STAFF RECOMMENDATION 2018 10th Avenue South July 18, 2018

Application: New construction—infill (revisions to a previously approved plan)
District: Waverly-Belmont Neighborhood Conservation Zoning Overlay
Council District: 17
Map and Parcel Number: 10509047900
Applicant: William Smallman
Project Lead: Melissa Sajid, melissa.sajid@nashville.gov

Description of Project: Application is to revise infill that was approved by MHZC in June 2018.

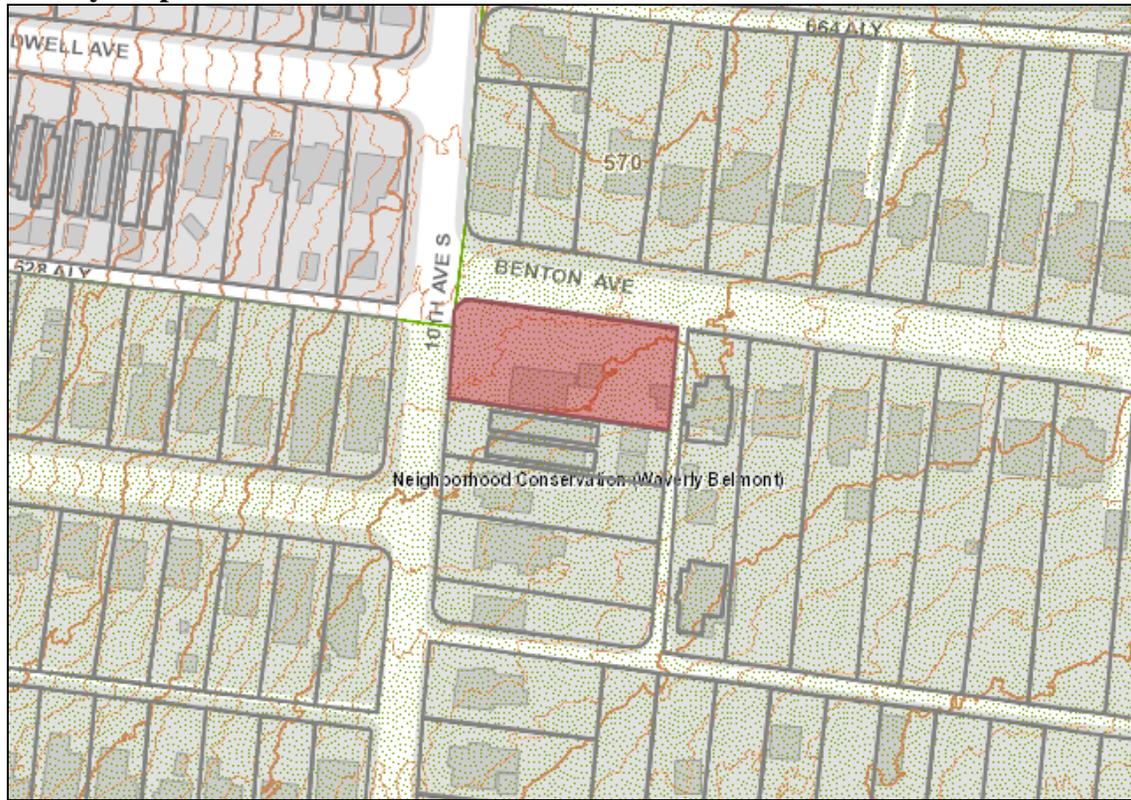
The plan approved by MHZC in June 2018 broke up the dormers, which helped the rear portion of the infill read as one and one-half (1.5) stories (Figure 2). The revised plan connects the dormers to create one wide dormer (Figure 3). Staff finds that wider, single dormer to be inappropriate as it reads more as two-stories while the historic context is predominantly single-story. In addition, Section III.E.2. of the design guidelines states that "small roof dormers are typical throughout the district." For these reasons, staff recommends that the side dormer be broken up so that it is not one large dormer.

1. The dormer on the right side façade shall be broken up so that it is not one large dormer;
2. The finished floor height shall be consistent with the finished floor height of the adjacent historic house, to be verified by MHZC staff in the field;
3. The front setback shall be consistent with the buildings to either side, to be verified by MHZC staff in the field;
4. The site plan shall incorporate a walkway leading from the front porch to the public sidewalk;
5. Vehicular access shall be from the alley;
6. Staff shall review and approve all materials prior to purchase and installation; and,
7. The HVAC shall be located behind the house or on either side, beyond the mid-point of the house.
